CONVAIR

COMMERCIAL CHANGE PROPOSAL

CUSTOMER Swissair Transport Co., Ltd.

MODEL: 30-6 (Convair "990")

Enclosure: (A) One copy Page 47b - PILOT'S AND COPILOT'S PEDESTAL
(Revised 5-31-61)

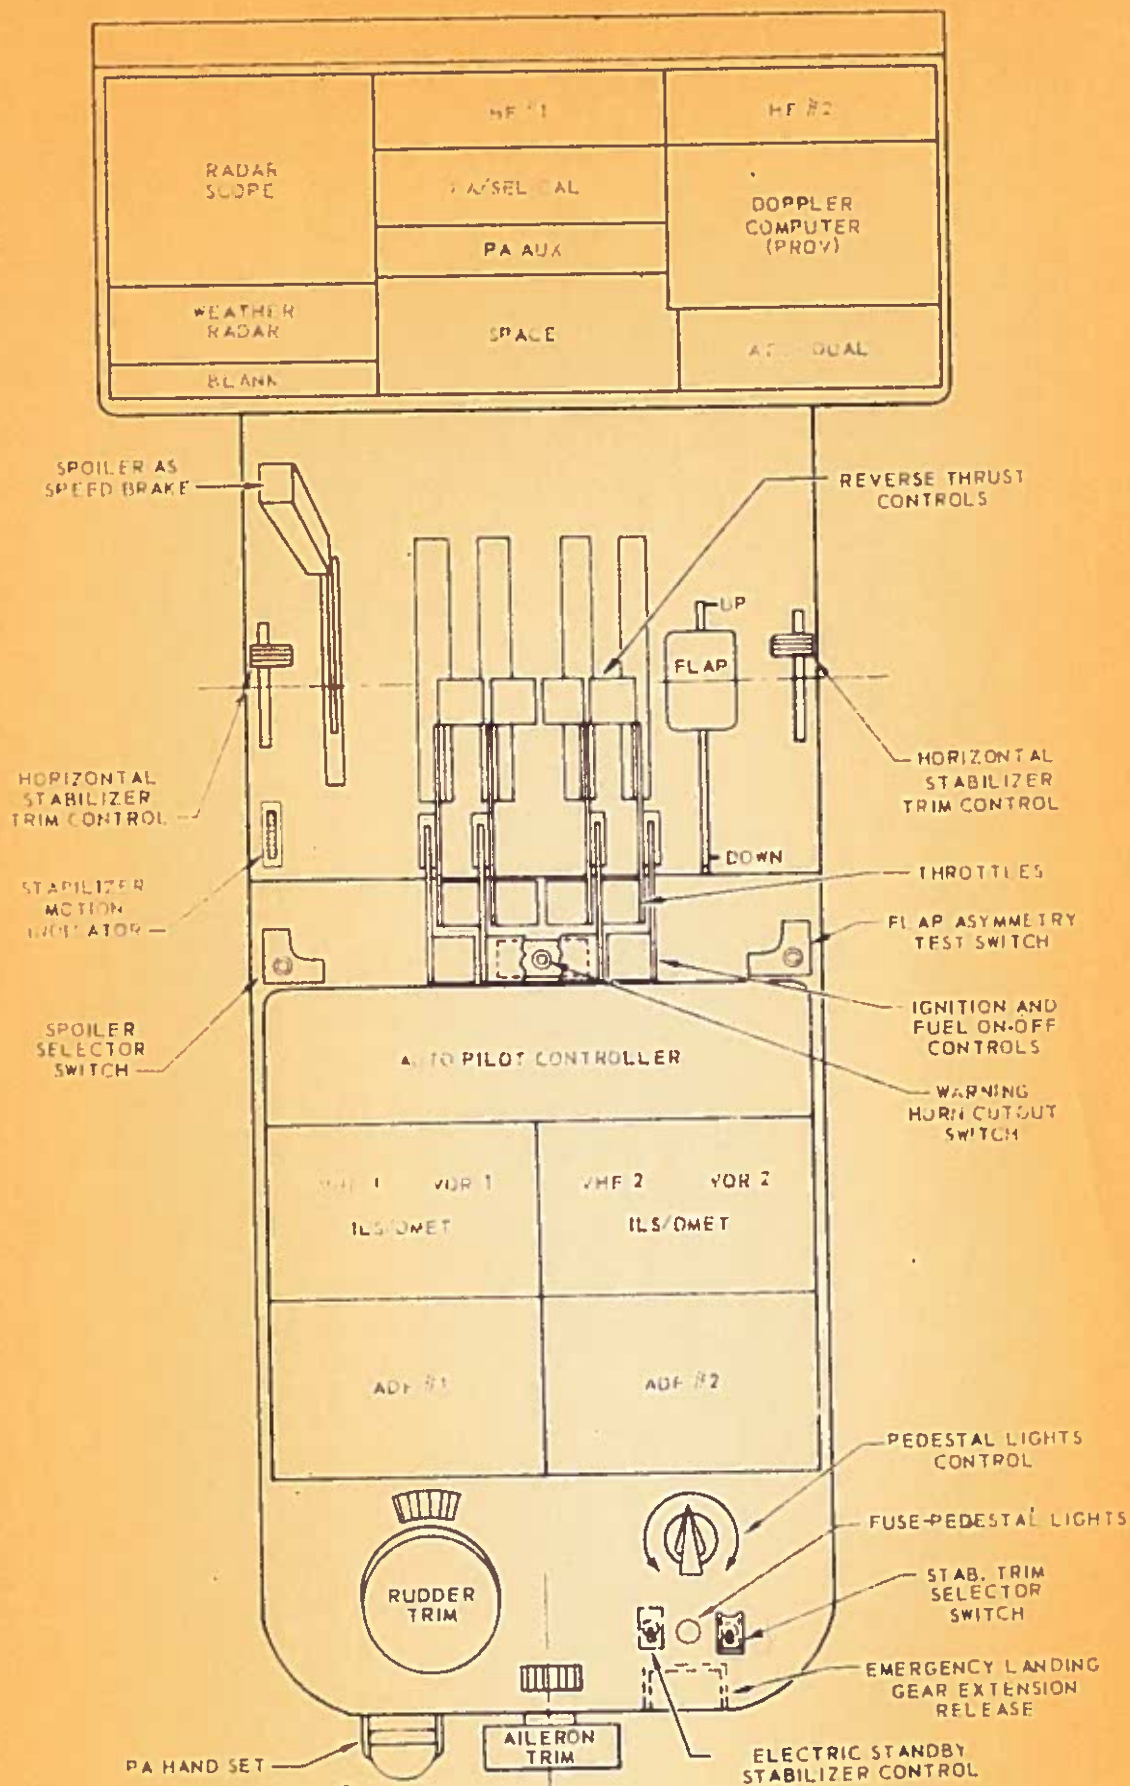
Replace the above illustration in the specification with Enclosure (A) which revises the stabilizer trim control, adds "STABILIZER MOTION INDICATOR", "FLAP ASYMMETRY TEST SWITCH", "FUSE-PEDESTAL LIGHTS", and "WARNING HORN CUTOFF SWITCH", and shows minor nomenclature changes in callouts; and deletes "EMERGENCY MANUAL HORIZONTAL STABILIZER TRIM".

Enclosure: (A) One copy Page 85a - ANTENNA ARRANGEMENT (Revised)

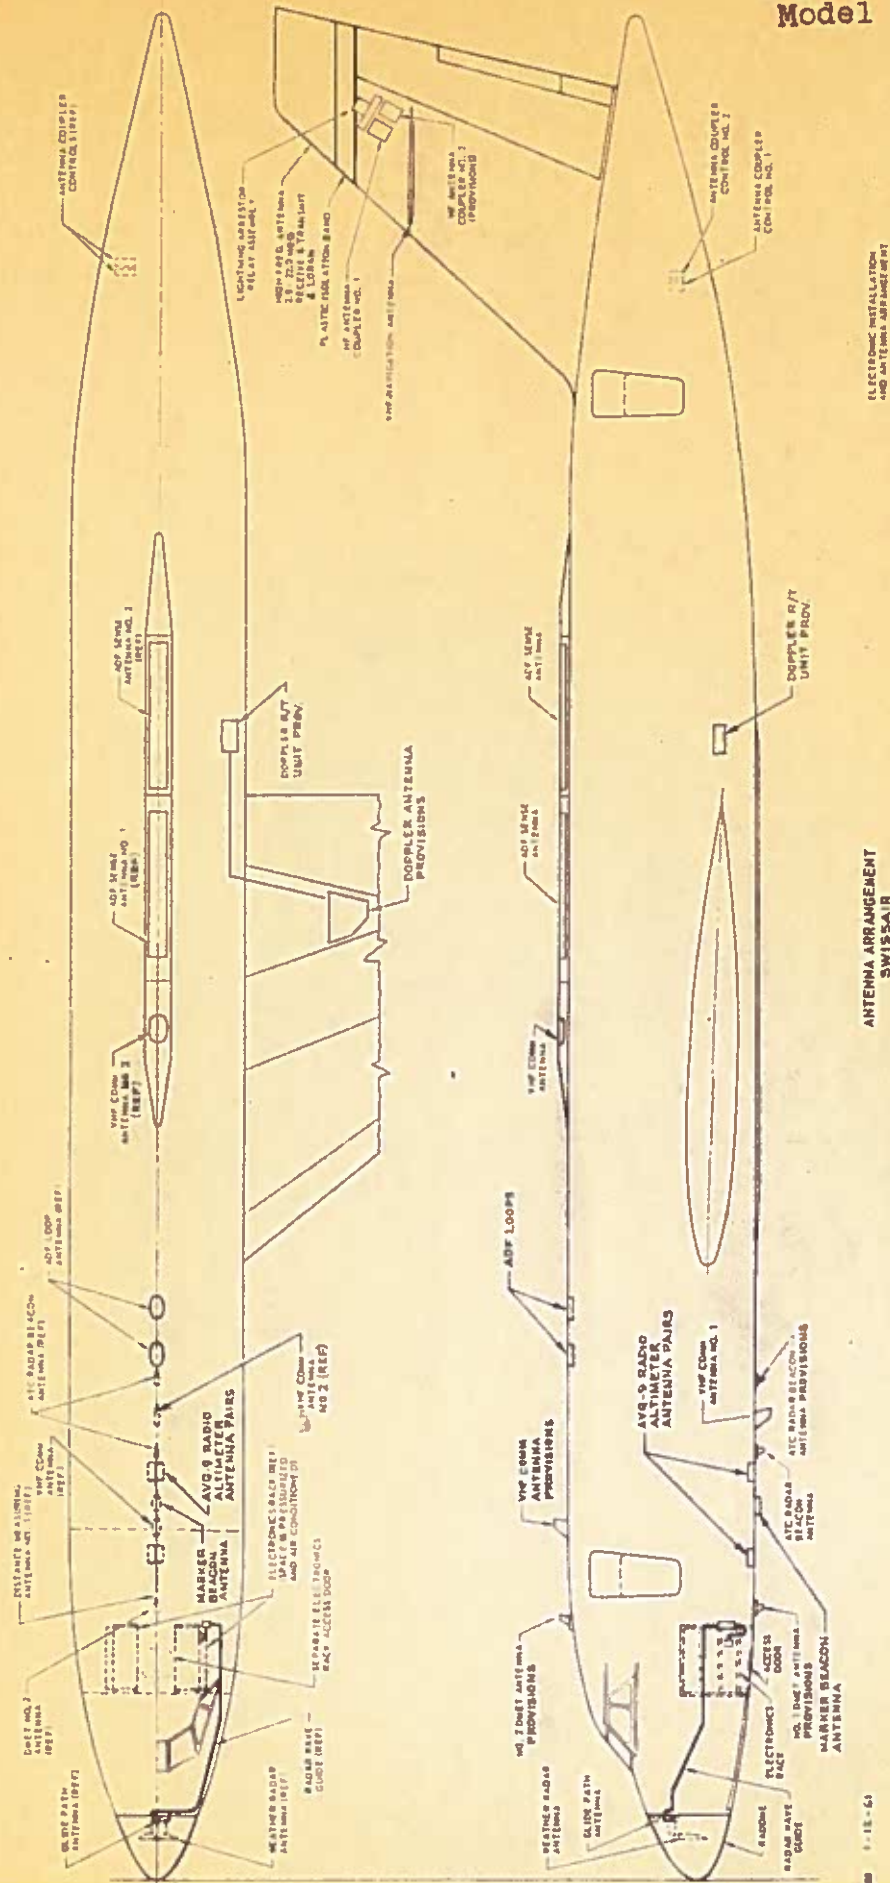
Replace above illustration in the specification with Enclosure (A) which shows the AVQ-9 radio altimeter antennas.

Enclosure: (A) One copy Convair Sketch - HORIZONTAL STABILIZER
MECHANICAL MOTION INDICATOR (For information
only, not part of specification)

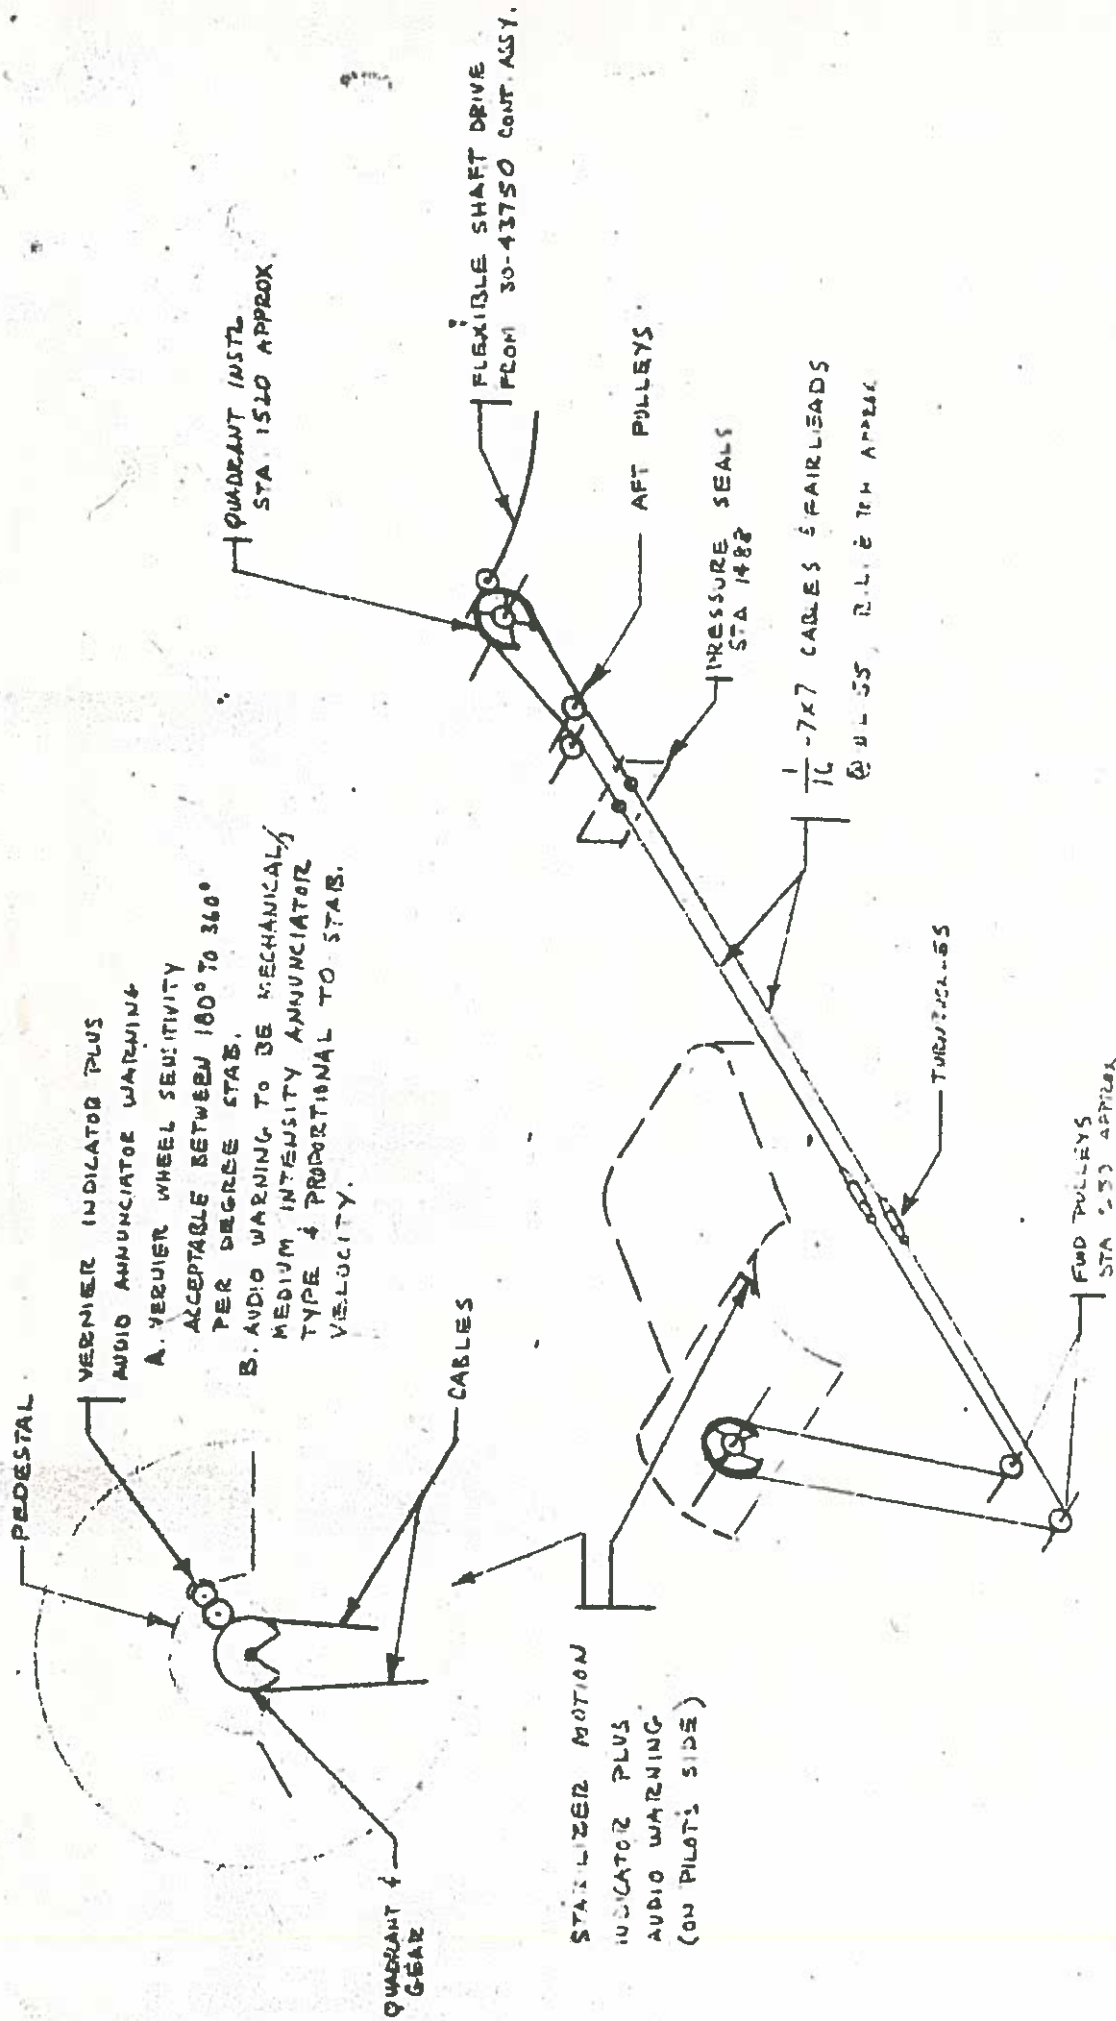
Estimated Weight Empty:	+6.0 pounds
Effect on Balance:	+4,970 inch-pounds
Effect on Payload:	-6.0 pounds
Effect on Performance:	None

Enclosure: (A) One copy Page 102a - GASEOUS OXYGEN SYSTEM (Revised)

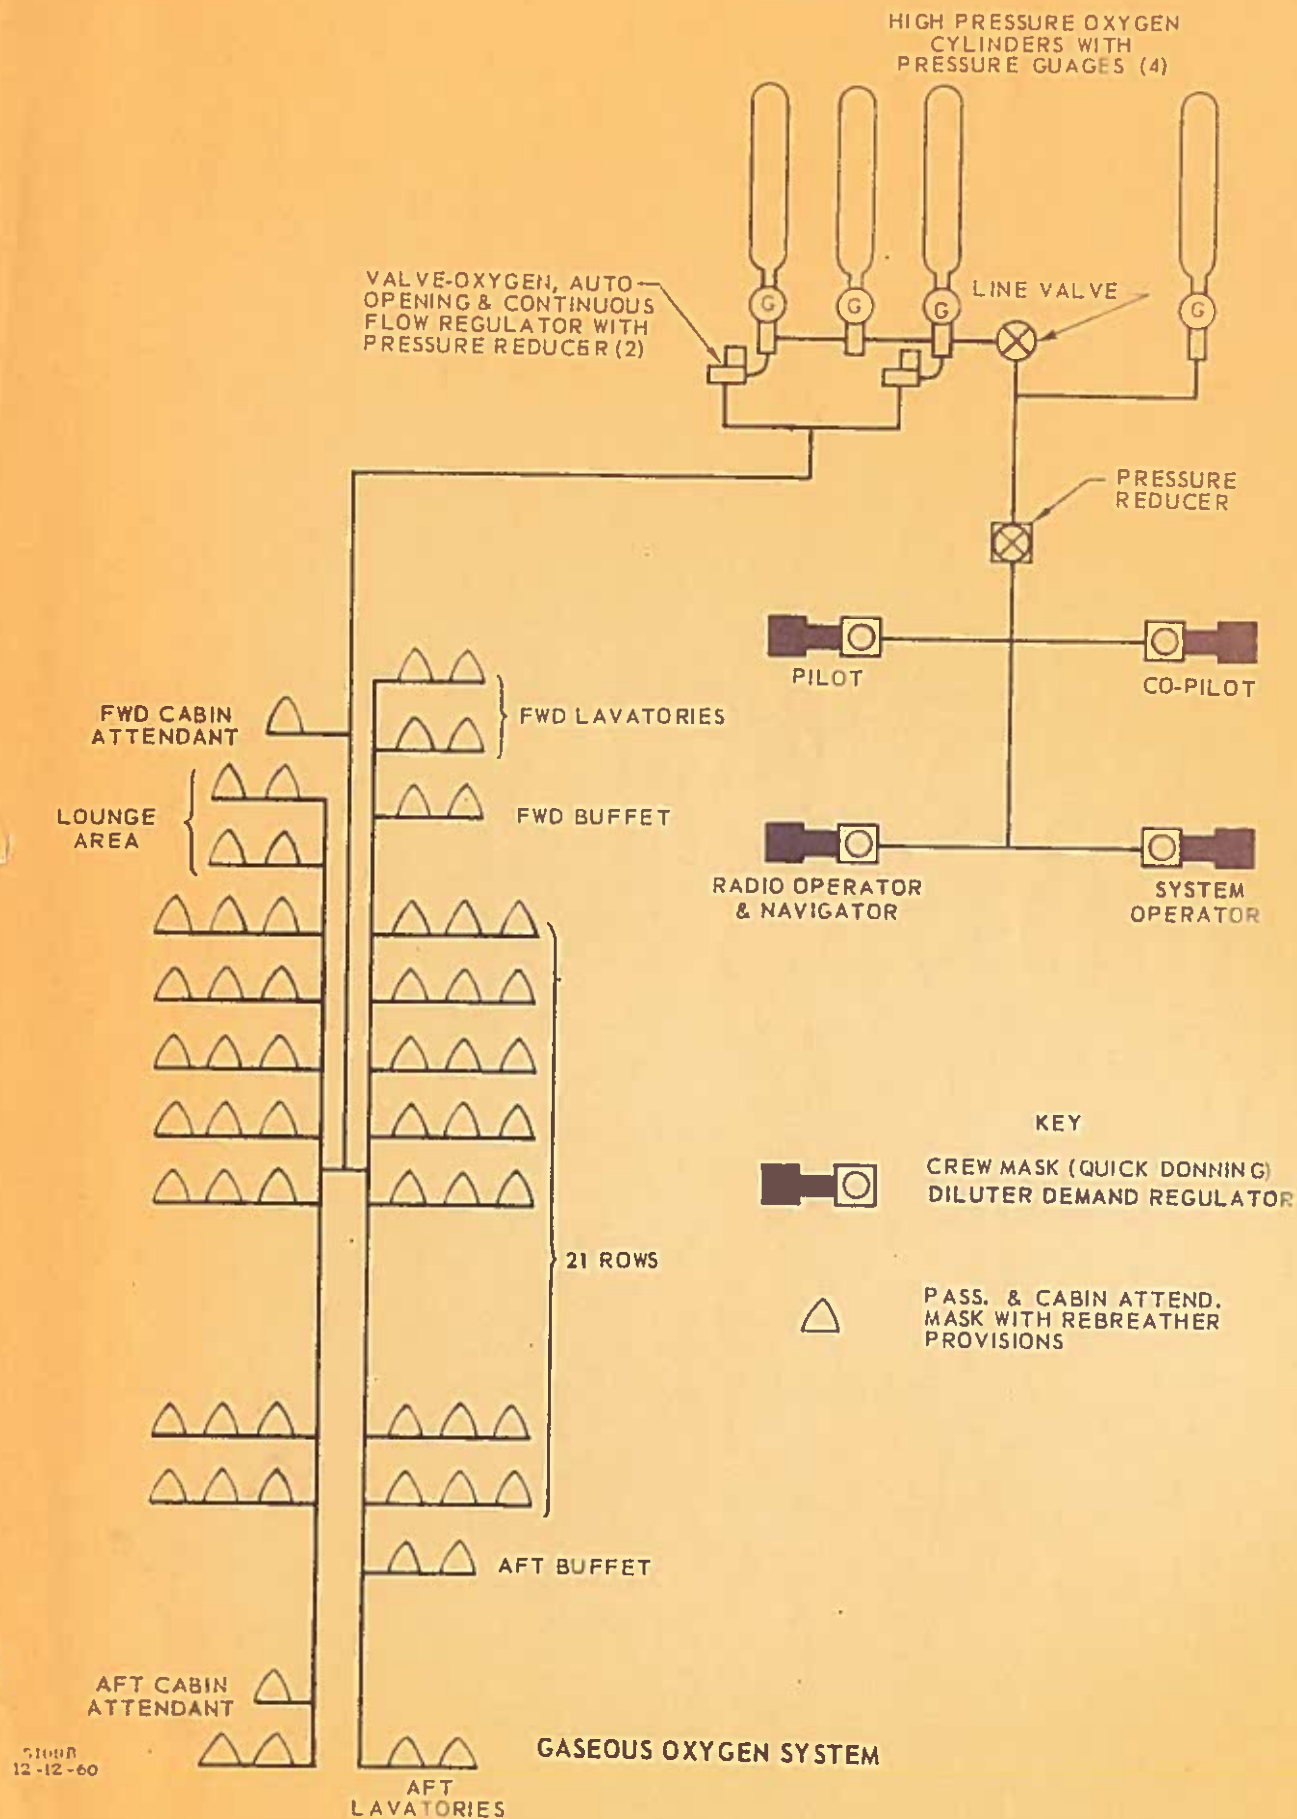
Estimated Weight Empty:	0
Effect on Balance:	0
Effect on Payload:	0
Effect on Performance:	None
